RE: Information Requested by UDOGM for Sediment Ponds No.3
and No.5, Star Point Mines

Subject: Embankment Stability Analysis of Sedimentation Pond Nos. 3 and 5,
Plateau Mining Company, Wattis, Utah.

Figure 1. Stage capacity curve for Sediment Pond No. 3

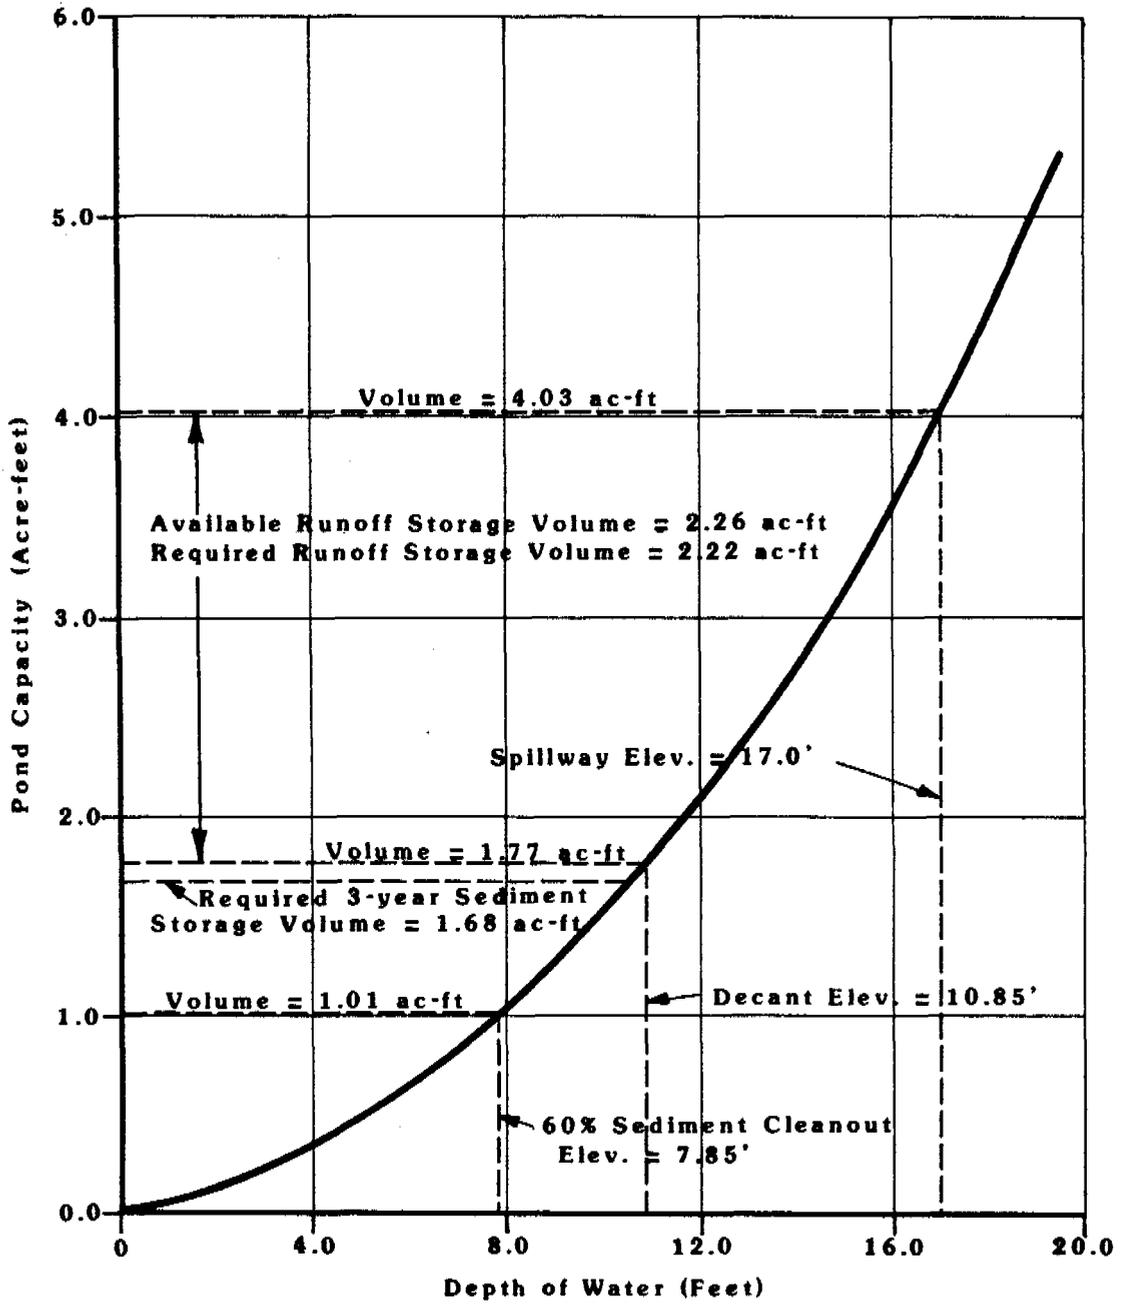
From the "as built" survey conducted by Mr. Bruce Ware, an "as built" topographic map was prepared for each of the sediment ponds. The topographic maps for each of the ponds are attached hereto for your reference (Attachments 1 and 2). From the topographic maps prepared by Mr. Ware, stage capacity curves for each pond were developed. The stage capacity curves are attached hereto as Figures 1 and 2 (Attachments 3 and 4).

Most Critical Failure Surface (F.S.=1.47)

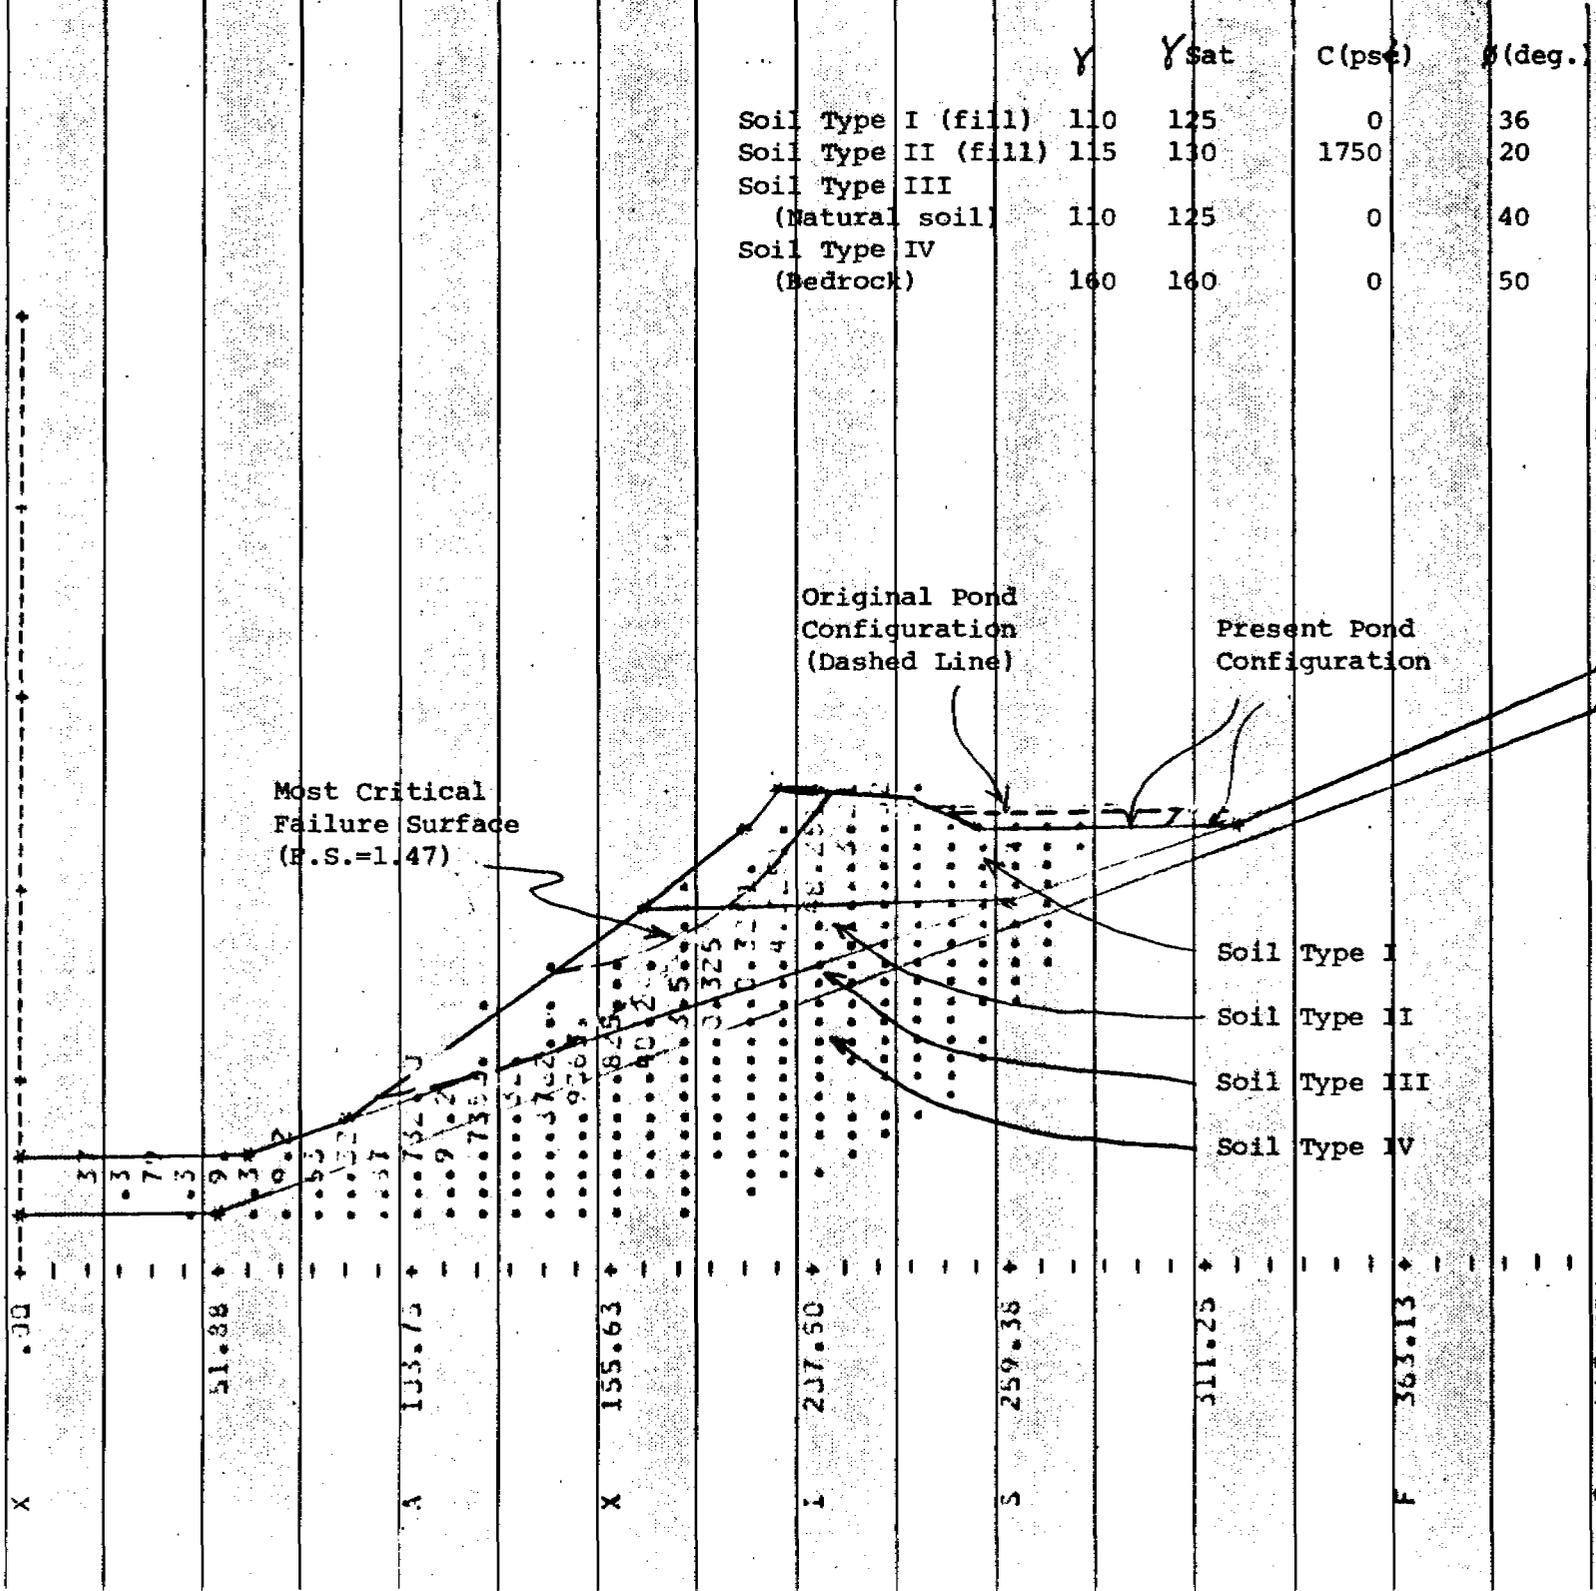
Copies of the graphical output of the STABL2 program are presented on the attached Drawing Nos. 1 through 4.
